STAFF REPORT

Planning Commission Meeting: March 9, 2020

Application:	<u>RZ19-0023:</u> Rezoning from BP (Business Park) District to C-2 (Community Center) District and a revised preliminary site development plan for Chinmaya Mission
Location:	Southwest of 153 rd Street and Pflumm Road
Owner:	Dwight Beachboard; Rew Kansas Properties LLC
Applicant:	Rajasree Prakash; Chinmaya Mission Kansas City
Engineer:	Murali Ramaswami
Staff Contact:	Kim Hollingsworth, AICP, Senior Planner

A3.1
BUILDING ELEVATIONS

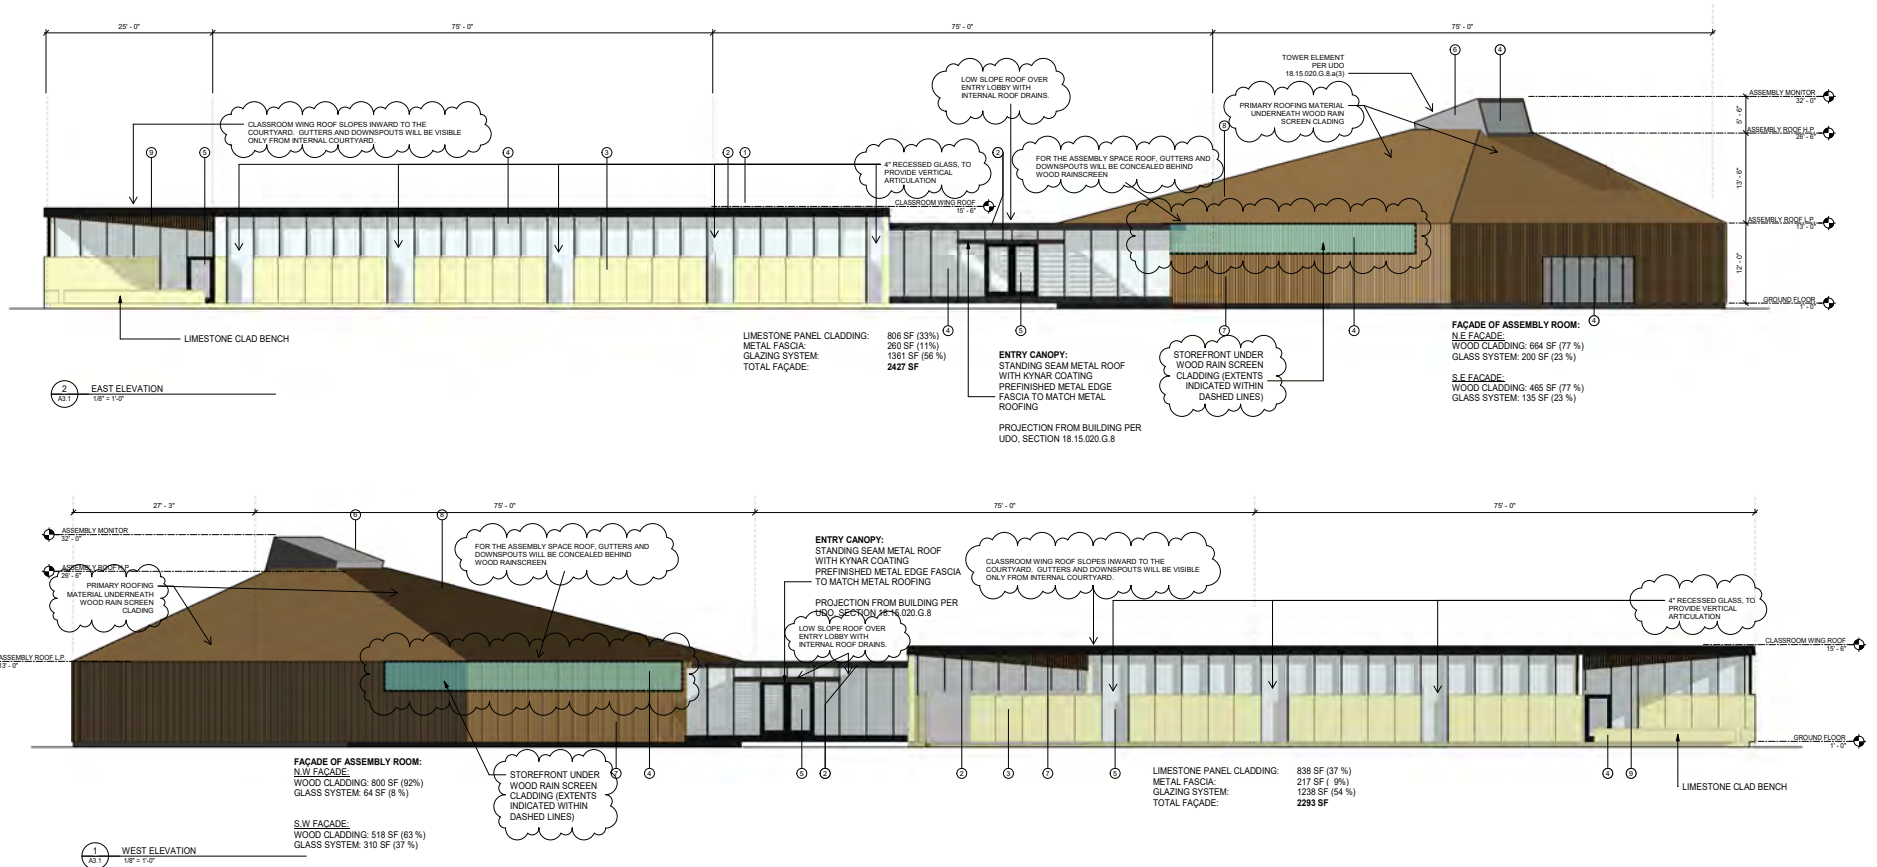
Religious institutions in nonresidential zoning districts are subject to the “Office and Civic” building design standards provided in UDO, Section 18.15.020.G.8. Conceptual renderings and elevations were provided with the preliminary site development plan that indicate the proposed building materials and architectural style. Significant amounts of glass are proposed along with a limestone veneer to be incorporated on façades of the classroom building. The assembly space is proposed to be clad with glass on all sides, with a wood rainscreen mounted to the exterior of the building. The main entry to the building will be covered with a canopy and a tower feature on the assembly space reaching a total of 31 feet in height to meet façade expression requirements.

The primary south and east façades of the proposed building are required to contain a minimum of two (2) materials from Class 1 or two (2) materials from Classes 1 and 2 on a minimum 70% of the façade, with a minimum of 25% clear glass. The applicant will be incorporating additional vertical and horizontal articulation, increasing the quantity of Class 1 building materials, and decreasing the amount of metal trim provided on the building through the final site development plan.
